**AGENDA
CITY OF CEDAR FALLS, IOWA
PLANNING AND ZONING COMMISSION MEETING
WEDNESDAY, JANUARY 23, 2019
5:30 PM AT CITY HALL**

TO: Planning and Zoning Commission
FROM: Iris Lehmann, Planner II
Matt Tolan, Civil Engineer II
DATE: January 17, 2019
SUBJECT: Greenhill Village Townhomes II – Preliminary Plat

TO: Planning and Zoning Commission
FROM: Iris Lehmann, Planner II
DATE: January 17, 2019
SUBJECT: Greenhill Village Townhomes II – Site plan

SITE PLAN

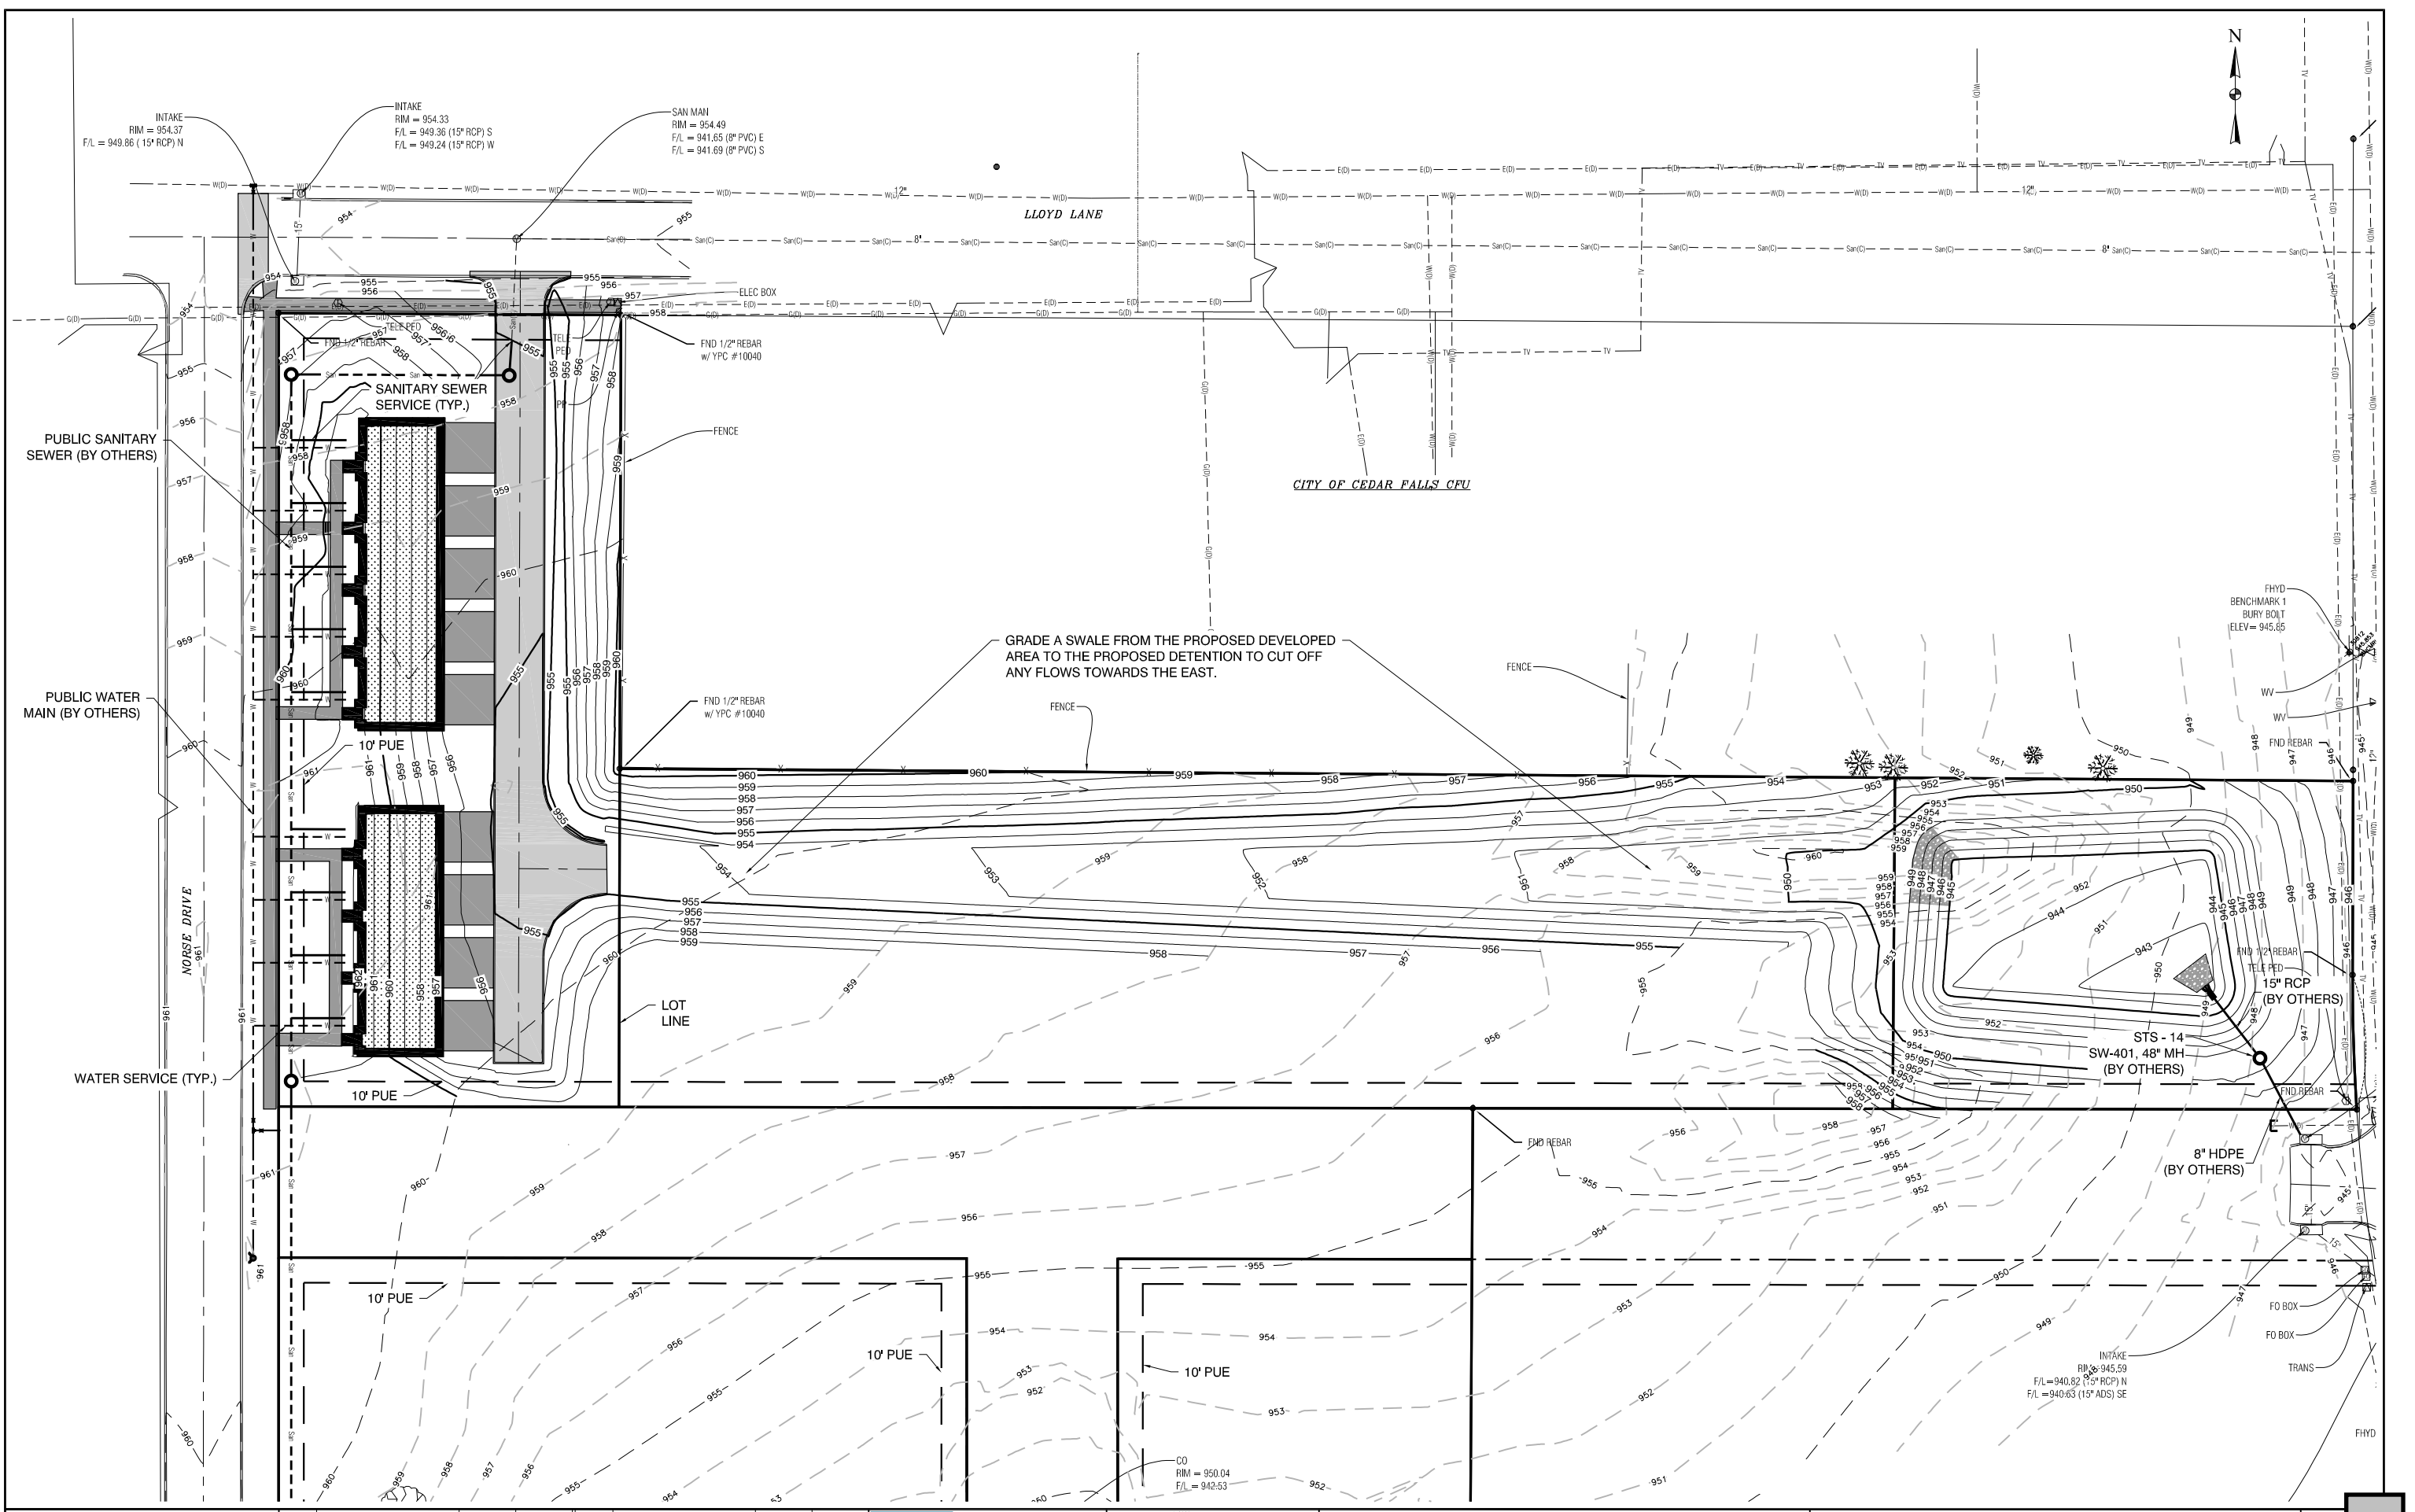
Future public sidewalk connection should be indicated on the site plan.

1. Enlarge all drawing plan views such that on an 11x17 sheet, they will scale properly.
2. Increase width of PUE to 20' around N/S sanitary main and include northern sanitary manholes/main within a PUE.
3. Add sidewalk along the eastern lot line of Tract B.
4. Add note for future sidewalk along the south side of Lot 1
5. On sheet C.300 remove "(By OTHERS)"
6. Revise and update sheet C.100 accordingly with any Preliminary Plat revisions
7. Submit final stormwater management report at time of construction plans.
8. On Sheet No.C.200:
 - a. Update the height details of the building so to be consistent with the elevations (should be 34' 11 1/4 ").
 - b. Site triangle details have not been provided.
 - c. Update required parking information. Three stalls are required per unit.
9. Landscaping Plan
